UNITED STATES PATENT AND TRADEMARK OFFICE

APPLICATION NO.	FILING DATE	FIRST NAMED INVENTOR	ATTORNEY DOCKET NO.	CONFIRMATION NO.
09/787,321	05/17/2001	Naohiro Hirose	P27675	7824

Office Action Summary

DETAILED ACTION

【図1】

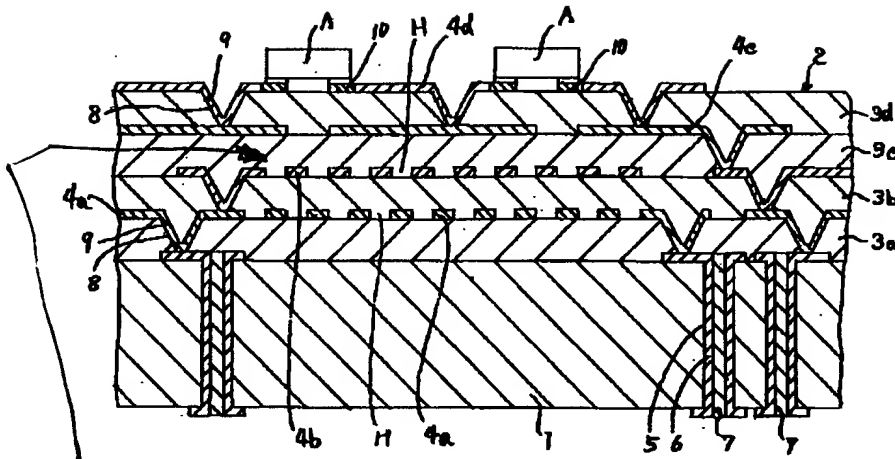
Regarding claim 4-7, Akira discloses all the features of the claimed invention as shown above including the chip mounted on the chip mounting region and the via land as shown on left side via of figure 1 is partly facing the chip mounting area as marked in red on the figure attached.

VIA PAD PARTLY BELOW
CHIP MOUNTING AREA
